To: Plan Holders for Improvements to the  
Washington County Airport  
Mineral Point, Missouri  
MoDOT Project No. 24-060A-1 & 24-060A-2

Transmitted herewith is **Addendum No. 1** to the Issued for Bid Contract Documents, Specifications and Plans dated May 28, 2024, for Improvements to the Washington County Airport.

**ADDENDUM NO. 1  
TO  
CONTRACT DOCUMENTS, SPECIFICATIONS AND PLANS  
FOR IMPROVEMENTS TO THE  
WASHINGTON COUNTY AIRPORT  
MINERAL POINT, MISSOURI  
MODOT PROJECT NO. 24-060A-1 & 24-060A-2**

EARTHWORK CALCULATIONS DETAIL (EXCAVATION)

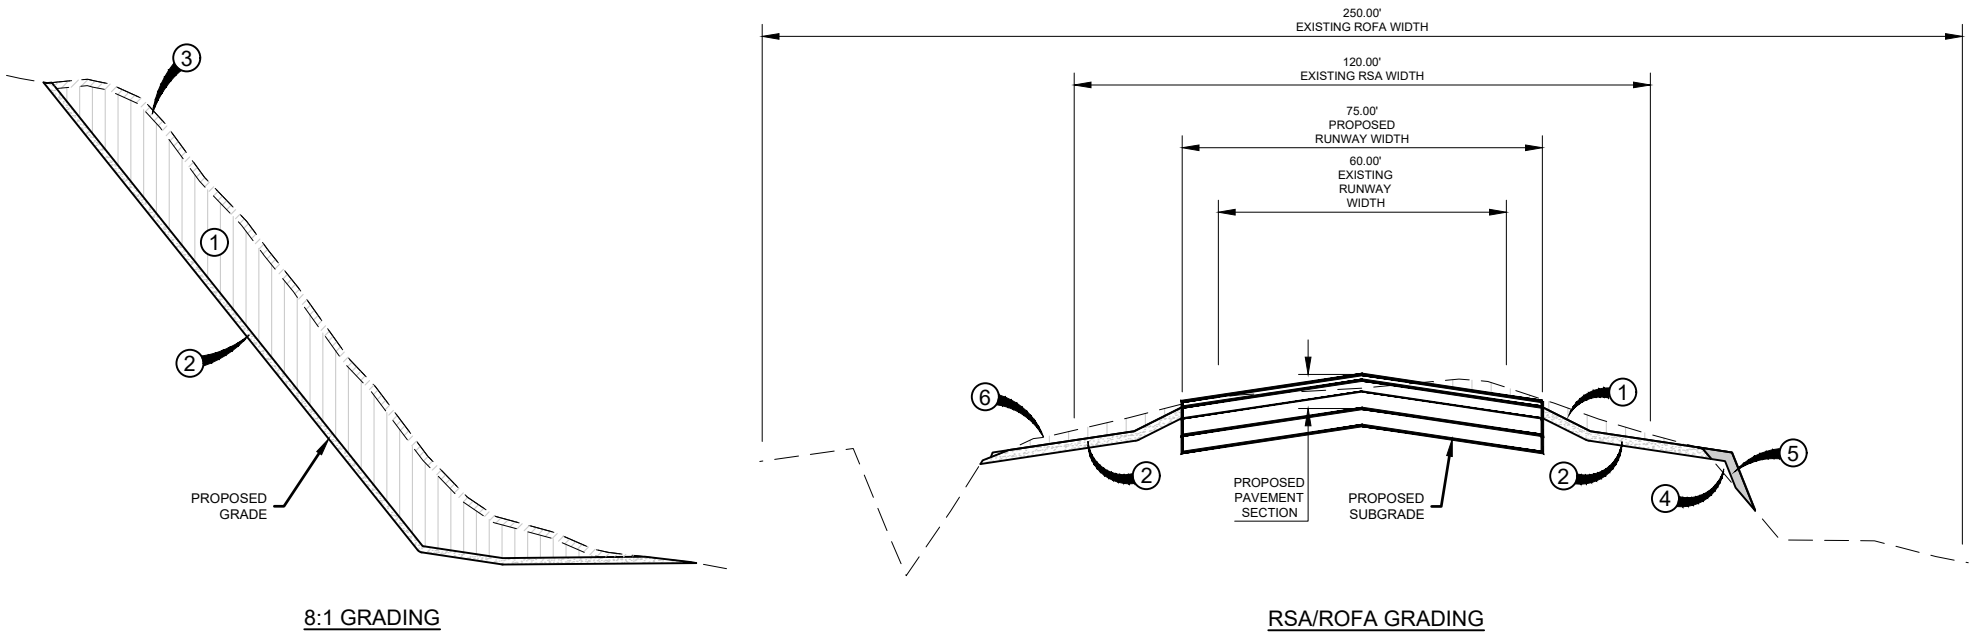
**Revision:** The Summary of Approximate Quantity table, Earthwork Summary table, and excavation detail have been updated

**Justification:** The summary of approximate quantity table quantities and item descriptions have been updated per the changes associated with this addendum. The earthwork quantities have been adjusted to reflect the changes with these addendum items. The earthwork calculations detail has been updated to be more clear on the "pay" and "no pay" item hatches.

G051

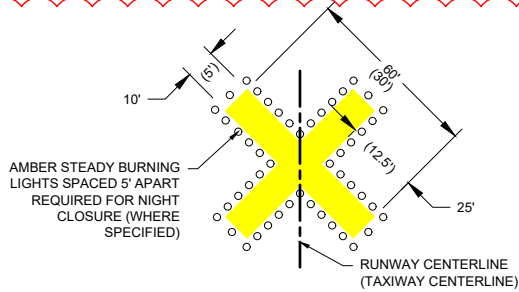
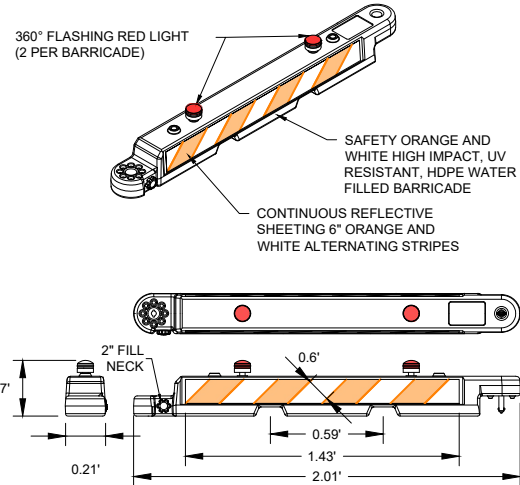
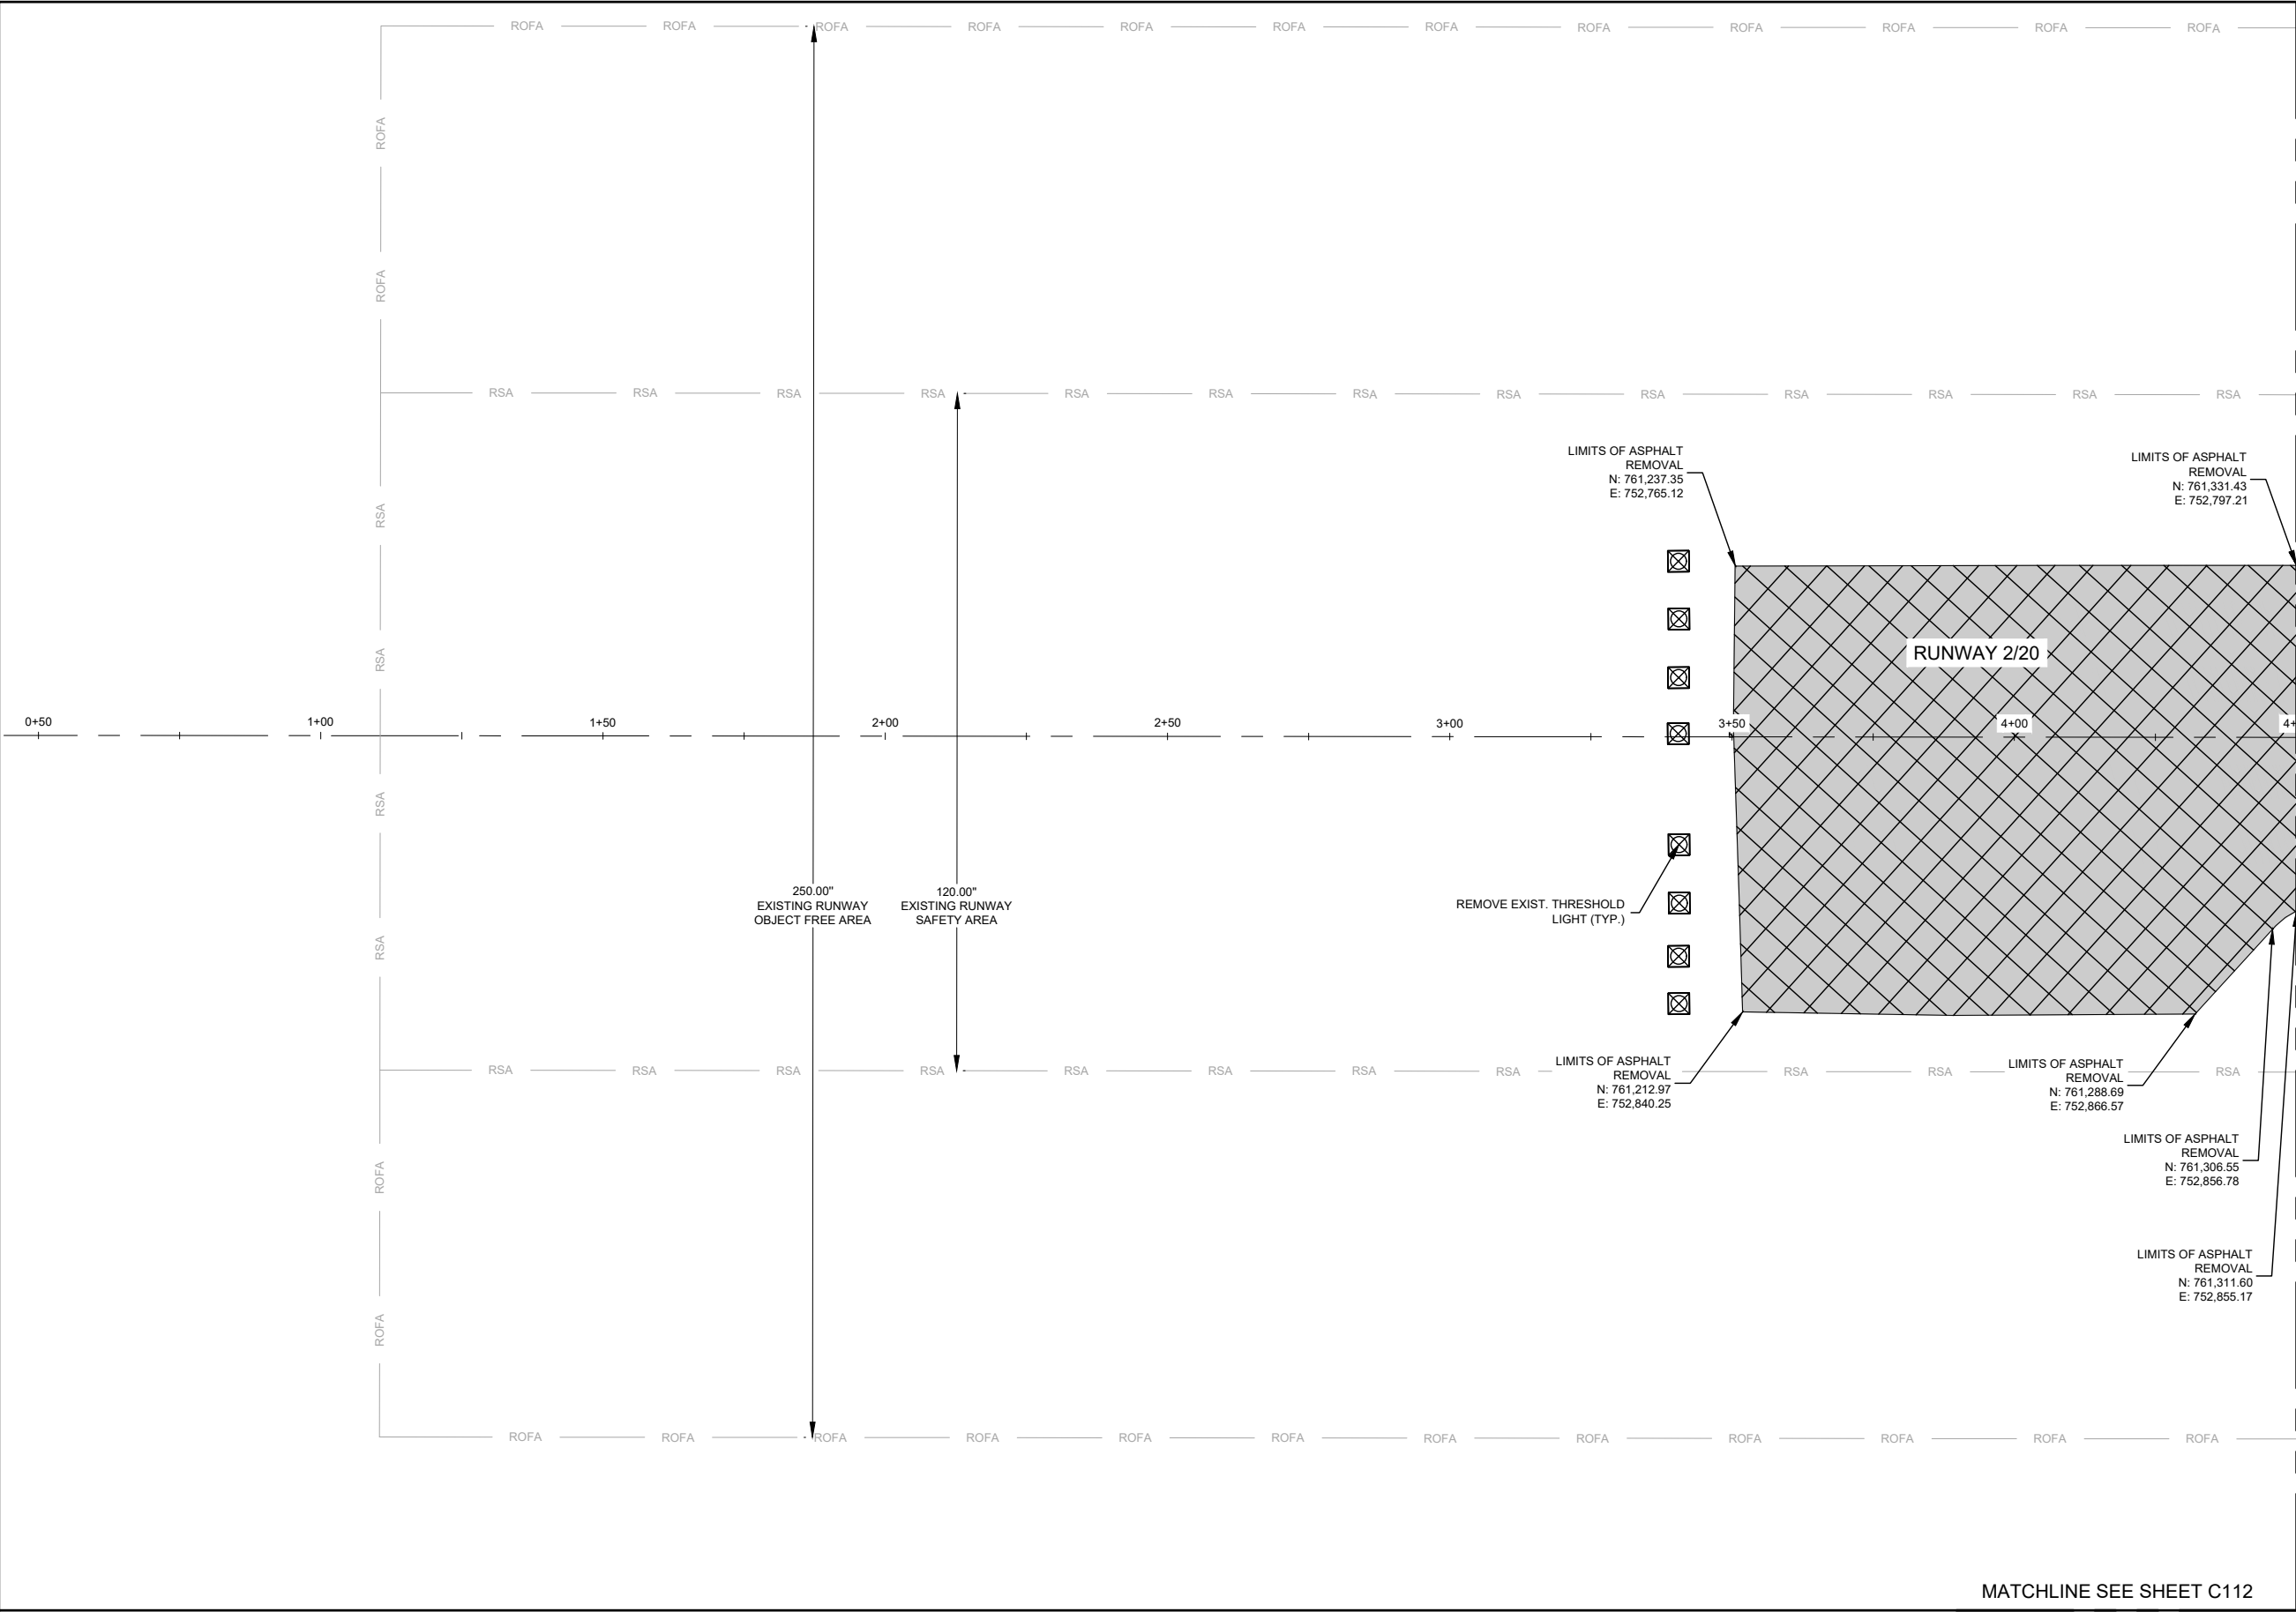
**Revision:** Runway Closure X detail updated. Lighted barricade detail added.

**Justification:** The lighted runway closure markers are not required, so a revised runway closure marker detail has been updated. The contractor may use the lighted barricades along the runway closure X.

**Answer:** The contractor may use the runway closure marker as noted on G051, which have been updated. The generator operated lighted runway closure markers are not required.

DEMOLITION PLAN STA. 0+50 TO 4+50 RUNWAY 2/20		SHEET NAME C100 SHEET NO. 25 of 145
MoDOT PROJ. NO. 24-060A-1 & 24-060A-2	WOOLPERT PROJ. NO. 1015274

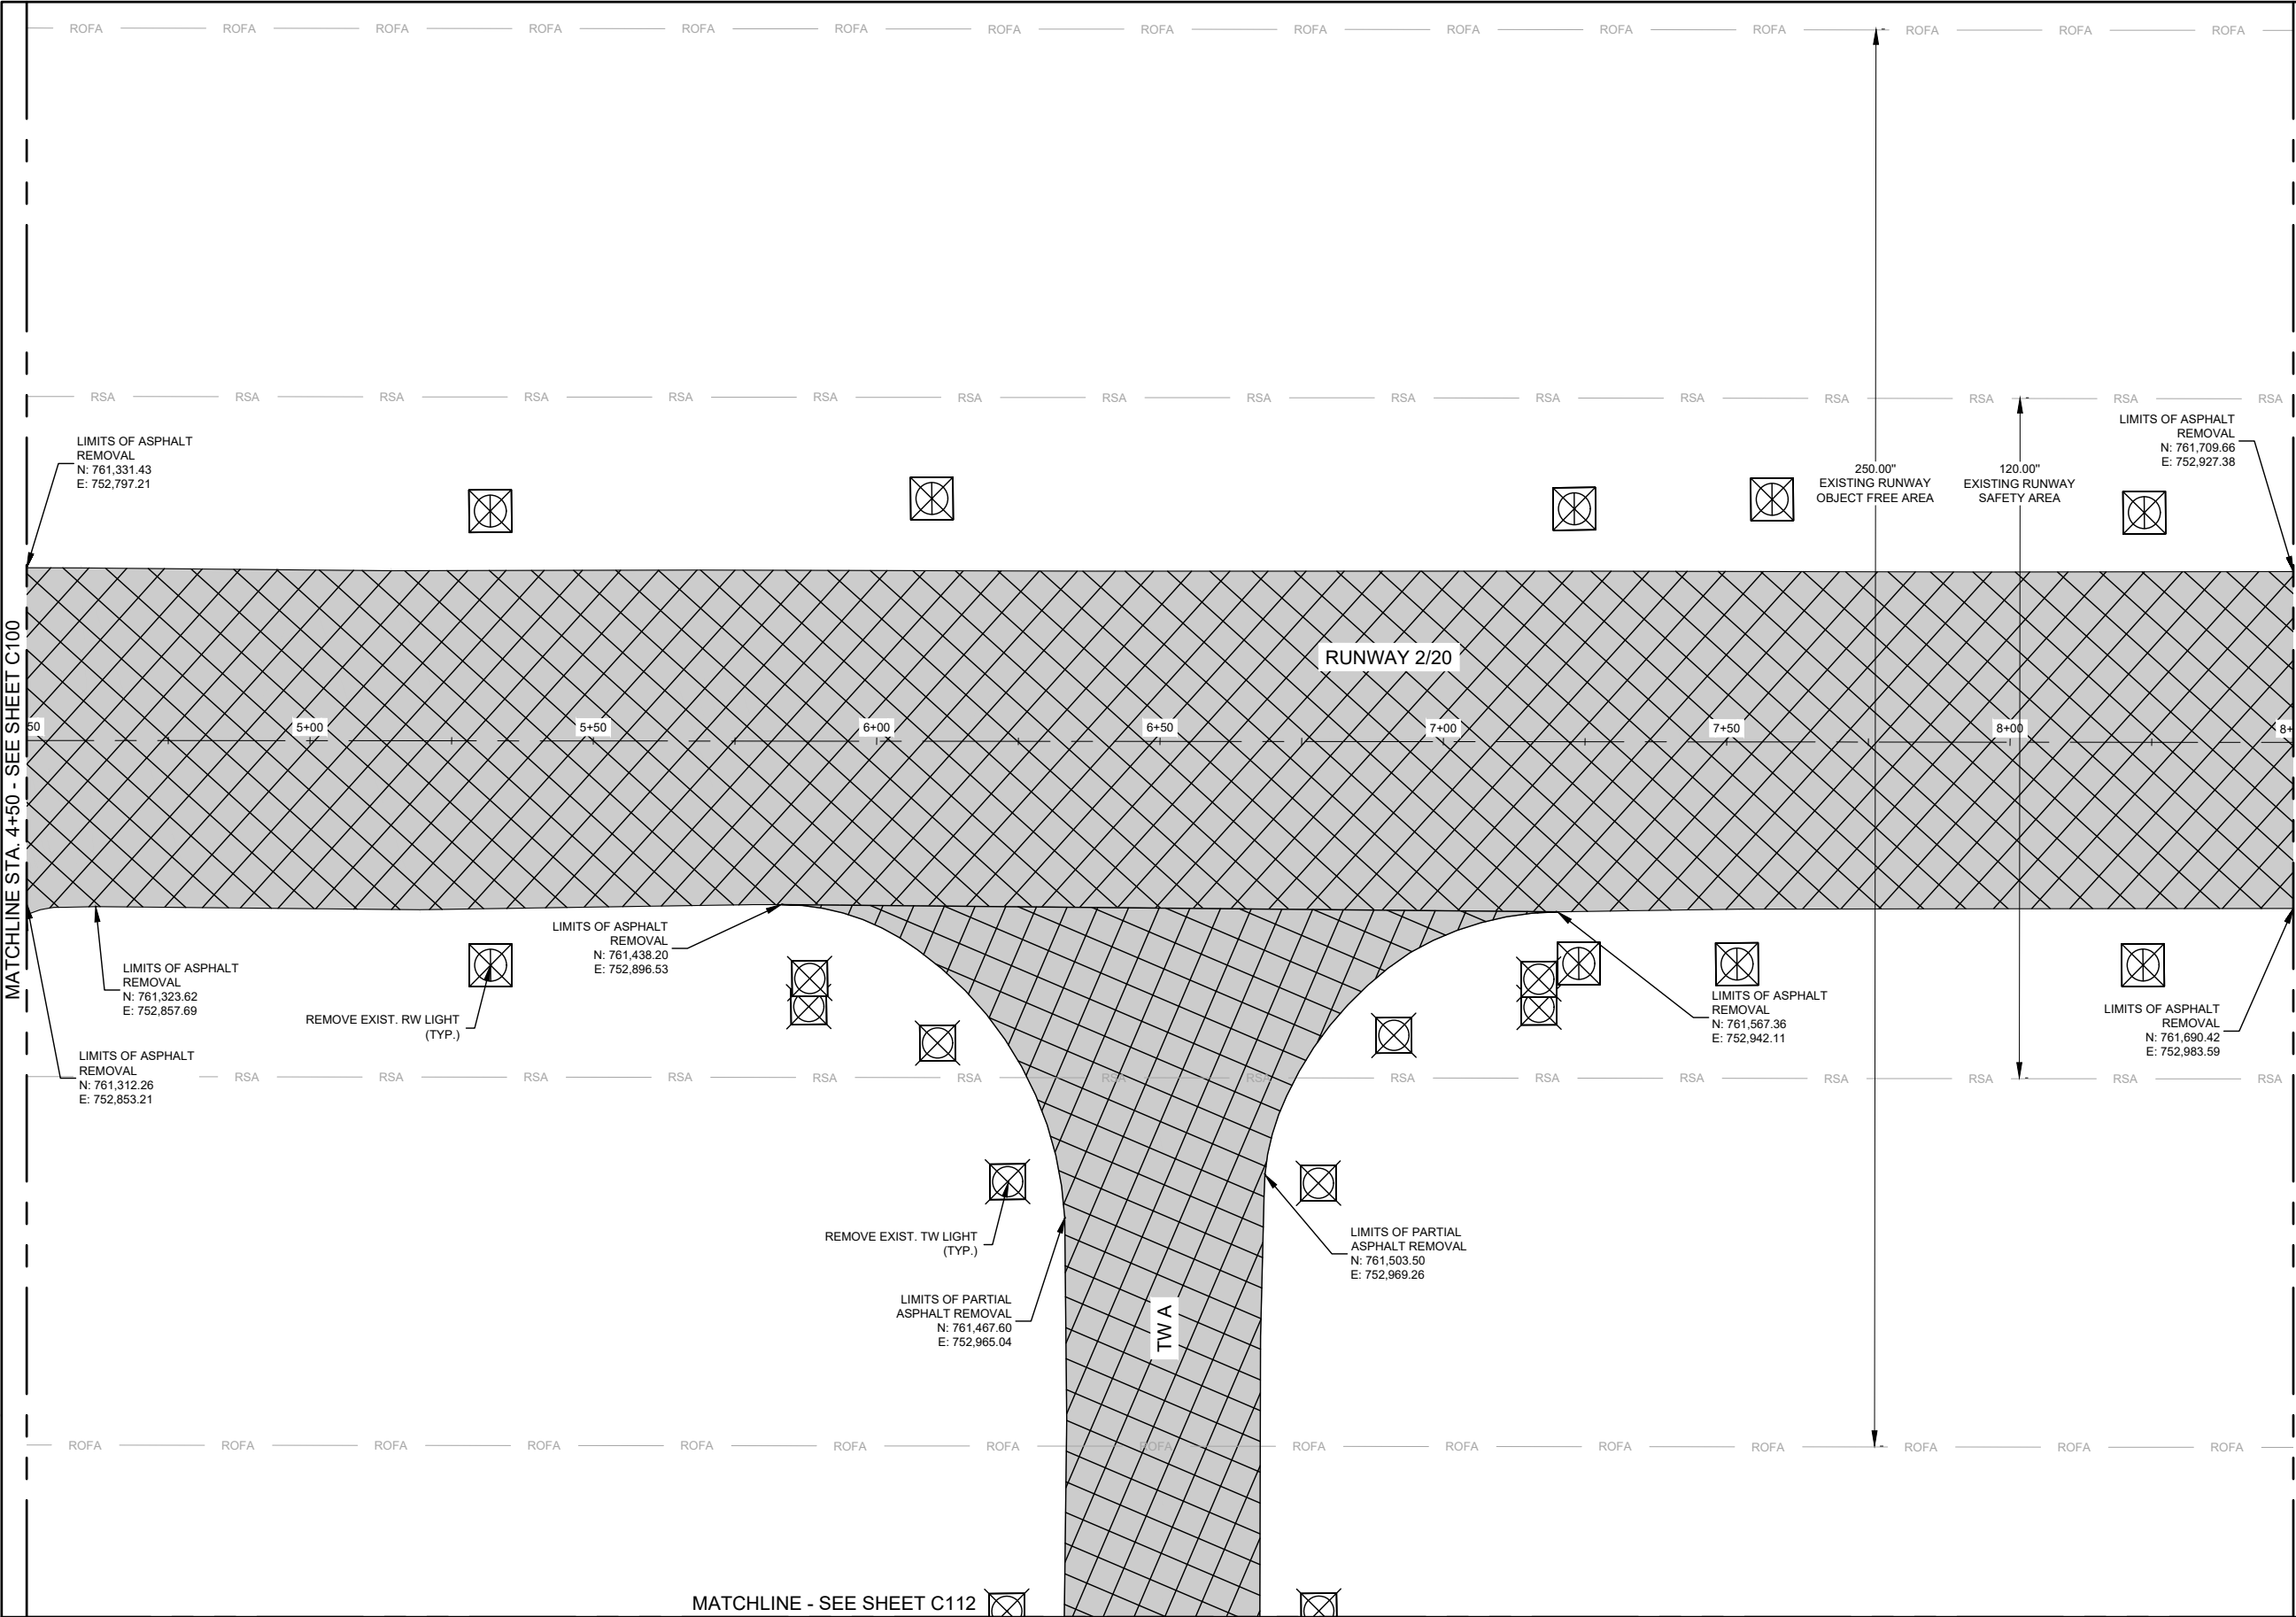
**Justification:** Updated the legend to include a 1.5" Nominal Depth for "Partial Depth Asphalt Removal" and remove the approximate depth from "Clearing and Grubbing".
